Access Compliance Report

Public Rights-of-Way

(Curb Ramps)

Intersection ID: 20047	Main Street: SHARON_RD	Cross Street: MORRISON_BV	Location: E
ADA ID: FFD27619539A	Ramp Type: PerpDiag	Initial Pass/Fail: Fail	Overall Compliance: No
Severity Score: 12.5			
Codes/Mitigation Info/Possible Solution		Field Measurements/Component Compliance

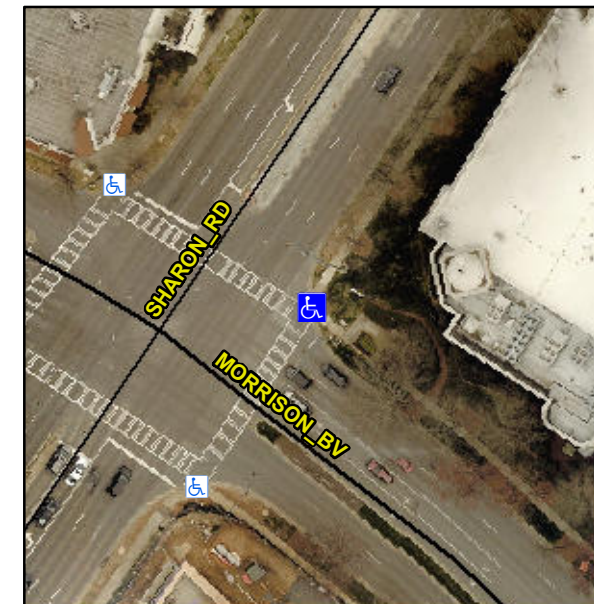
Compliance	Description	Data	Compliance	Description	Data
N/A	Ramp Length (in)	58.0	No	Ramp Slope (%)	10.5
Yes	Ramp Width (in)	48.0	Yes	Ramp XSlope (%)	1.5
N/A	Flare Type LT	N/A	N/A	Flare Type RT	N/A
N/A	Flare Slope LT (%)	N/A	N/A	Flare Slope RT (%)	N/A
N/A	Flare Traversable LT?	N/A	N/A	Flare Traversable RT?	N/A
N/A	Landing Length (in)	N/A	N/A	DWS Provided?	N/A
N/A	Landing Width (in)	N/A	N/A	DWS Contrast?	N/A
N/A	Landing Slope (%)	N/A	N/A	DWS Length (in)	N/A
N/A	Landing X Slope (%)	N/A	N/A	DWS Full Width?	N/A
N/A	Landing Curb? (Y/N)	N/A	N/A	DWS Offset (in)	N/A
N/A	Shared Landing?	N/A			
N/A	Gutter Ponding?	N/A	N/A	Gutter Slope (%)	N/A
N/A	Gutter Lip Ht (in)	N/A	N/A	Gutter X Slope (%)	N/A
N/A	Painted X Walk1?	Yes	N/A	Painted X Walk2?	Yes
	X Walk 1 Direction	To NW		X Walk 2 Direction	To SW
N/A	X Walk 1 Width (in)	111.0	N/A	X Walk 2 Width (in)	108.0
	X Walk 1 Slope (%)	2.9		X Walk 2 Slope (%)	1.3
	X Walk 1 X Slope (%)	1.0		X Walk 2 X Slope (%)	2.7

Remove & Replace Curb Ramp With Two New Directional Ramps or Equivalent.
